Subject: 2051 Folder, Instructions for replacement of original style home flag sensor with WRA2051144 retro-kit ('new' style home flag sensor)

Affected Machines:

Original style 2051/2045 home flag assembly---Note 2 piece arrangement of sensor/housing.

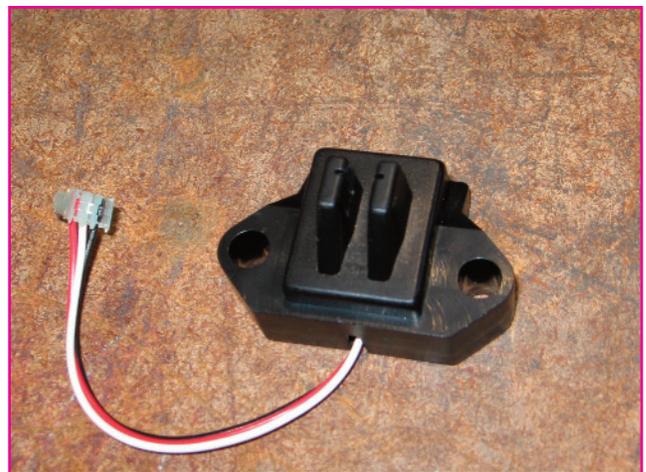
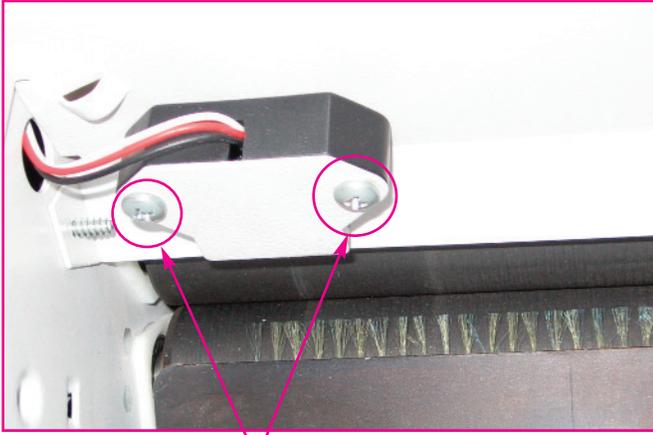
Identification: The first step in fold table sensor replacement is identifying the sensor to be replaced and confirming that it is the 'old' style. Pictures of both the old and new style sensors are given below for reference. If the part being removed is the same style as the replacement, the software set-up modifications presented below are to be ignored.

New style (WRA2051144) replacement home flag assembly---Note 1 piece construction.

Background: At the machine S.N.'s given above, the home flag sensors were upgraded from the original '2-piece' design to a more robust '1-piece' design. These instructions outline the steps necessary to replace the original home flag sensor with the style supplied with the WRA2051144 retro-kit.

1st Fold Table Home Flag Sensor mounting screws

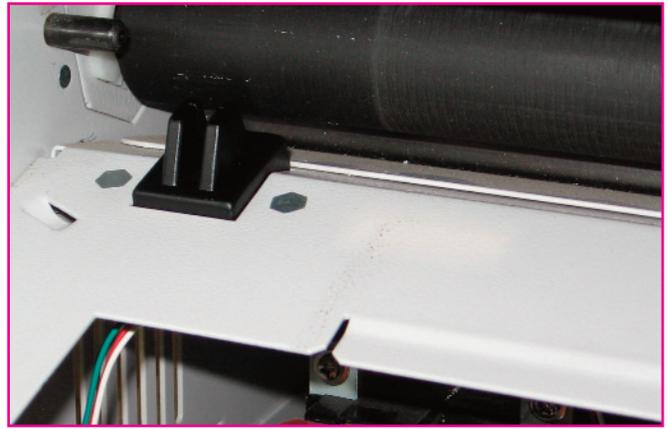
Sensor replacement: *WARNING: Unplug the Folder before performing any service on it.* Removal and replacement of the home flag sensors is largely self-evident by inspection. Replacement of both involves removing (2) philips mounting screws and unhooking its electrical connection. Removal of the 2nd fold table home sensor requires removal of the access panel located under the 2nd fold table. Removal of the 1st fold table home flag sensor may require removal of the folder's front cover in order to access its electrical connector.

2nd Fold Table Home Flag Sensor-Mounting screws are underneath

1st Fold Table offsets screen in diagnostic #7

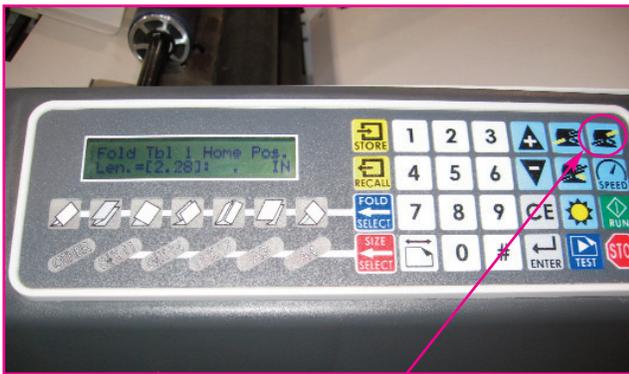
- A. Power up the folder in diagnostic mode by holding down the 'STOP' button while turning the unit on. It is necessary to hold the STOP button down continuously until the diagnostic screen appears on the folder display. Then press '7' to access the offset limit settings.
- B. Once in the offset limit setting diagnostic menu, press the fold table button on the display that corresponds with the fold table system the technician is working with. Press the button for the first fold table if you replaced the home flag sensor for fold table #1 and press the button for the second fold table if you are working with that system instead.

2nd Fold Table offsets screen in diagnostic #7

Offset value screen-Record number in brackets

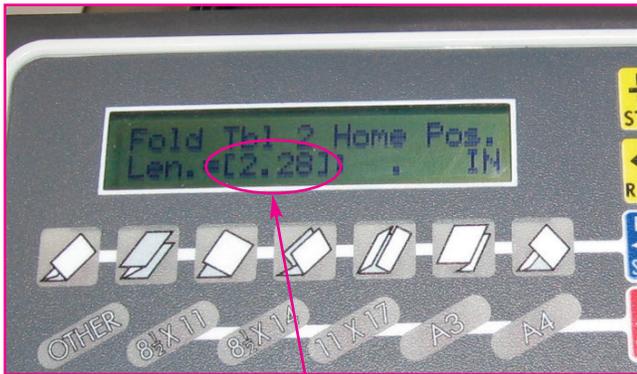
C. When the fold table button is pressed a screen appears that reads: Fold Tbl X Home Pos. Len.=[X.XX]: . IN. Record the bracketed value on the display for 'X.XX'. It should be a number from approximately 2.27 to 2.30. Once you record that number, add .05 to it and enter that number on the display by using the keypad. For example, if the number given on the display is '2.28', add .05 to that to get 2.33. Then type the '2.33' value on the display. Once the new value is on the display press 'Enter'. If you replaced the first fold table home flag, you have finished with the software set-up and can move onto step 'E' below. If you replaced the home flag sensor for fold table #2, perform step 'D' below.

New value entered on display via keypad
